Date: Dec. 16, 1999

To: T10 Committee (SCSI)

From: George Penokie (IBM)

Subject: Comments resolution for SPI-3 Letter Ballot

Figure 1 - Example of a differential calibration trace

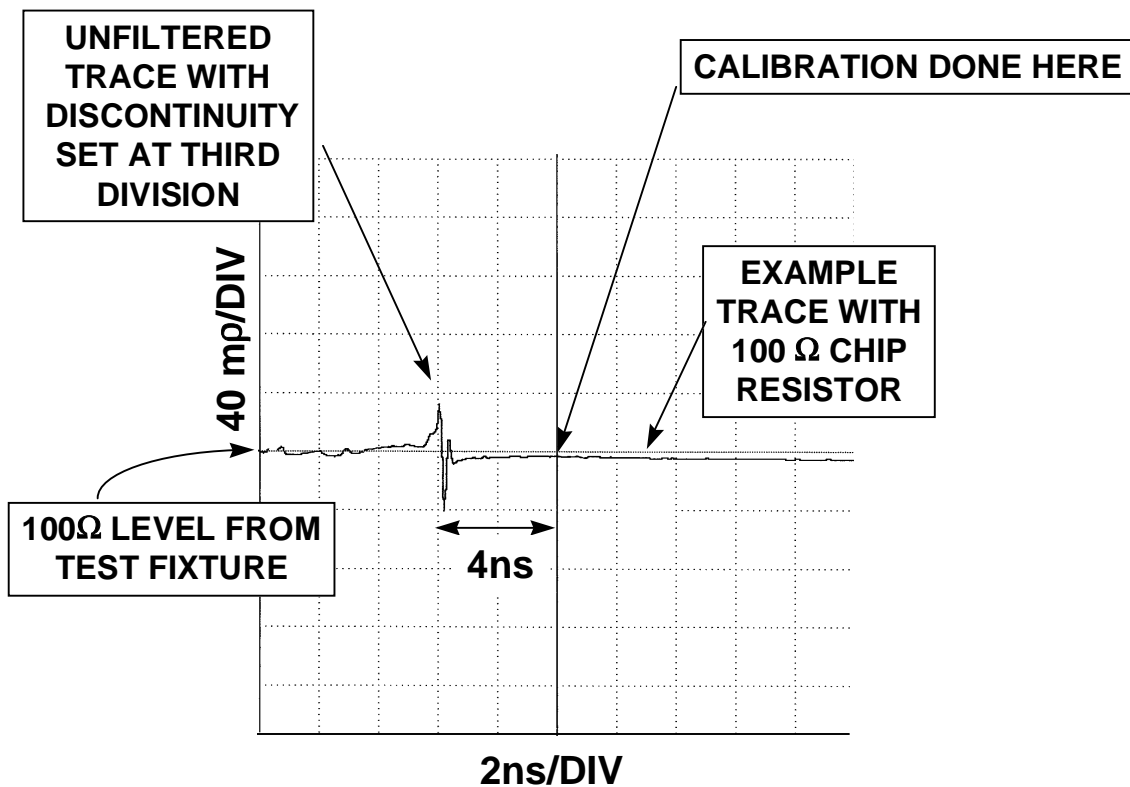
A figure is needed in section E.2.2.2.3 to illustrate the differential measurements.

Add the following words to section E.2.2.2.3 along with the Figure.

Figure x shows an example of a differential calibration trace.

Accept

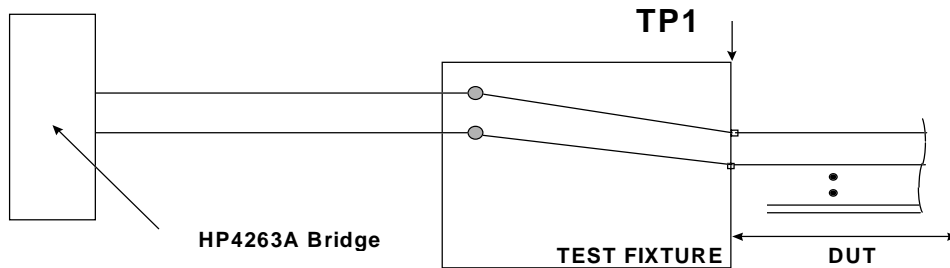
SPI-3: 62.30) technical

In section E.3.1.2

change: See E.2.2.2 for appropriate test fixtures.

To: Figure x shows the configuration to use for this measurement procedure.

Add the following figure x describing the test fixture to section E.3.1.2 with the title "Test fixture for single ended capacitance measurement".

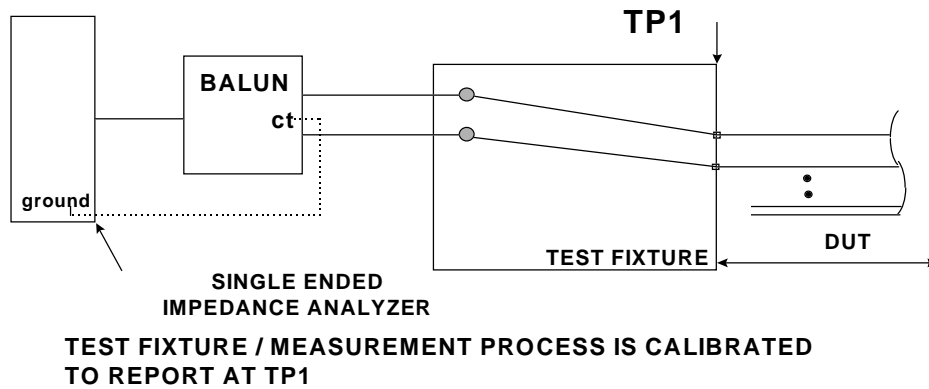
SPI-3: 68.36) technical

In section E.3.2.2

Change:

See E.2.2.2 for appropriate test fixtures.

Refer to Figure x for the proper test configuration.

[Add a new Figure x shown below titled "Test fixture for differential capacitance measurements"].

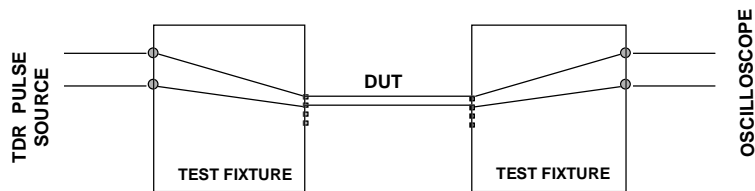
SPI-3: 78.46) technical

In section E.5.2 change:

To: See Figure x for appropriate test fixture.

Add new figure x given below showing the test fixture with the title "Propagation time measurement setup".

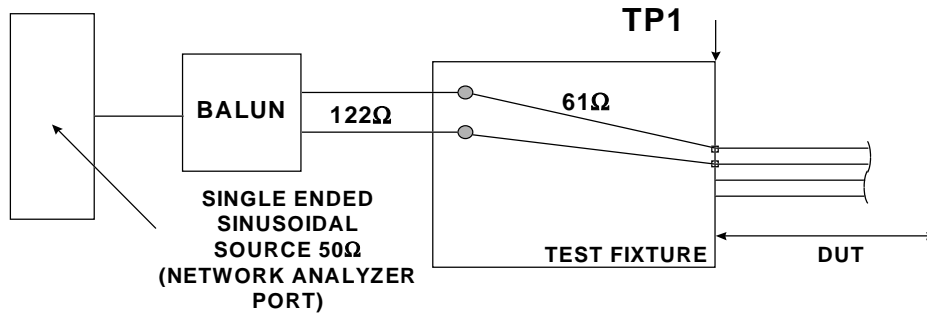
In section E.7.1.1 change

A test fixture having 75 Ω single ended paths for each signal line is used for the measurement as shown in

To:

A test fixture having 61 Ω single ended paths for each signal line is used for the measurement as shown in

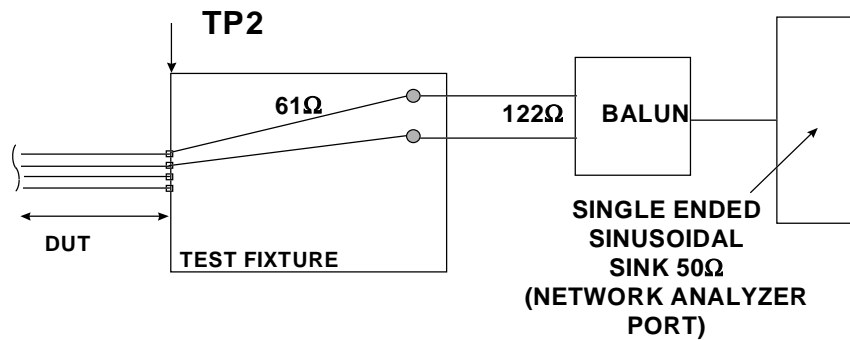
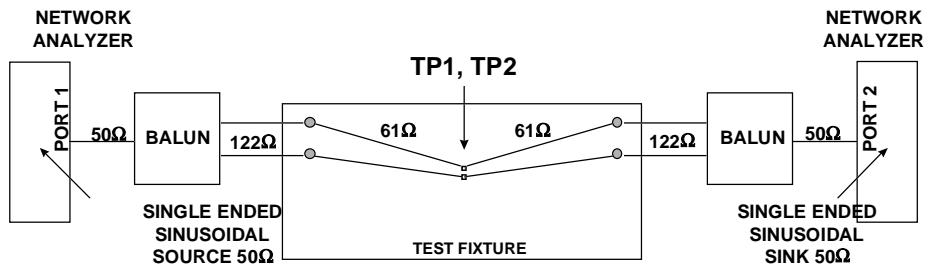
SPI-3: 88.56) technical

In section E.7.1.1 replace Figures E.12, E.13, and E.14 with the following respective figures: (same figure titles)

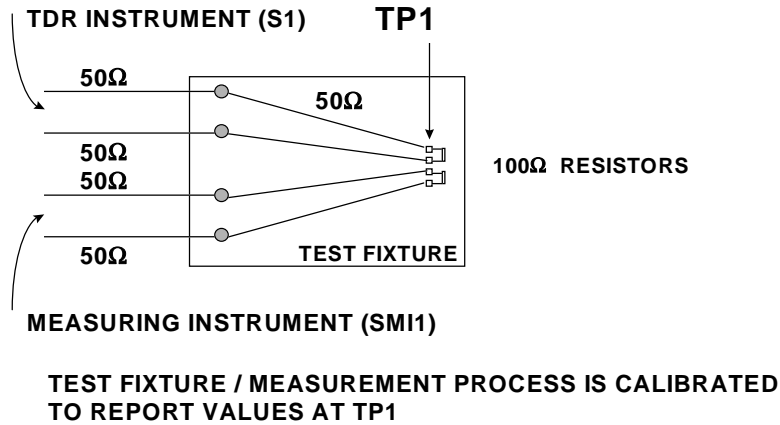
In section E.8.3 change Figure E.17 to:

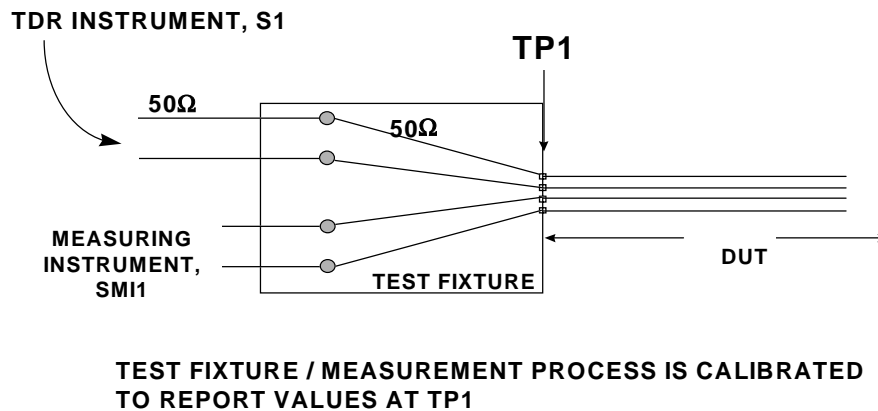
In E.8.4 change: Figure E.18 to:
